Scientific Analysis Administrative Change Notice

1. Document Number:	ANL-DSD-MD-000001	2. Revision:	01	3. ACN:	01
4. Title:	Aqueous Corrosion Rates for Waste Package Materials				
5. No. of Pages Attached:	11

Figure 6-21. Corrosion Rates of Titanium Grades 2, 5, 7, 16, and 24 in Boiling HCl

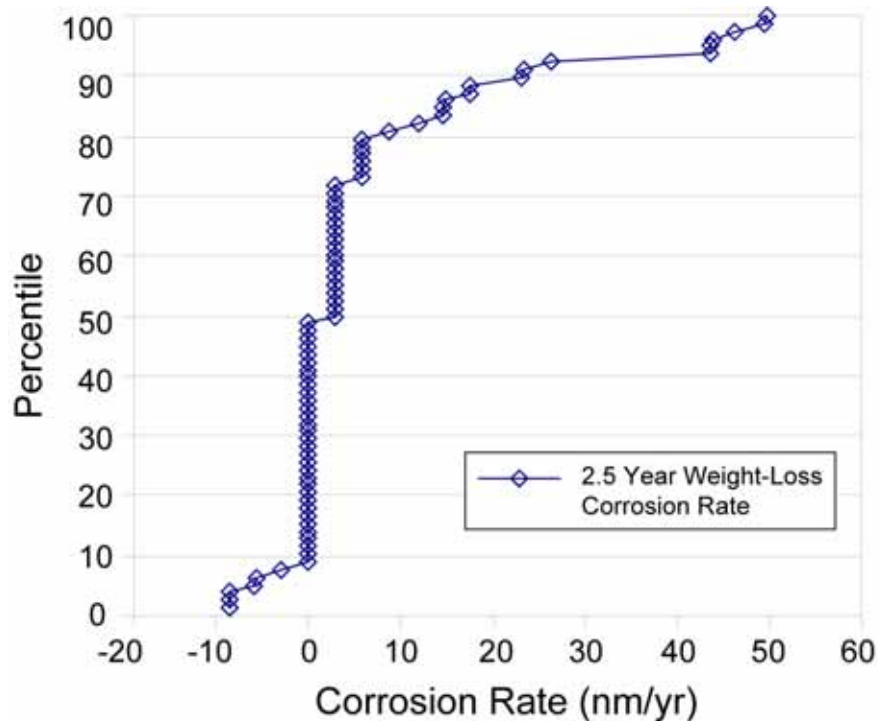
1. Document Number:	ANL-DSD-MD-000001	2. Revision:	01	3. ACN:	01
4. Title:	Aqueous Corrosion Rates for Waste Package Materials				
6-40	<p>Change figure number.</p> <p>Figure 6-22. Corrosion Rates of Titanium Grades 2, 5, 7, 16, and 24 in Boiling HCl</p> <p>Change to read:</p> <p>Figure 6-21. Corrosion Rates of Titanium Grades 2, 5, 7, 16, and 24 in Boiling HCl</p> <p>This change was self-identified.</p>				
6-40	<p>Editorial correction.</p> <p>Figure 6-22 “Corrosion Rates of Titanium Grades 2, 5, 7, 16, and 24 in Boiling HCl”, change footnote:</p> <p>Source: BSC 2004 [DIRS 169847] (Figure 10). To Source: BSC 2004 [DIRS 169847], Figure 10.</p> <p>This change was self-identified</p>				
6-40	<p>Text added for clarification.</p> <p>Section 6.5.2 “Titanium Grade 24”, page 6-40, insert the following text after the figure to read:</p> <p><i>General Corrosion and Localized Corrosion of the Drip Shield</i> (BSC 2004 [DIRS 169845]) plots all of the 2.5-year weight-loss data (vapor, aqueous, and water line) for Titanium Grade 7 from DTN: LL030410012251.056 [DIRS 169583] in the CDF shown in Figure 6-22. The corrosion rate from all weight-loss specimens at the 85% percentile of the cumulative distribution function is about 15 nm/yr.</p> <p>Note: This text is moved from page 6-39 to page 6-40 without any change to the content.</p> <p>This change was self-identified.</p>
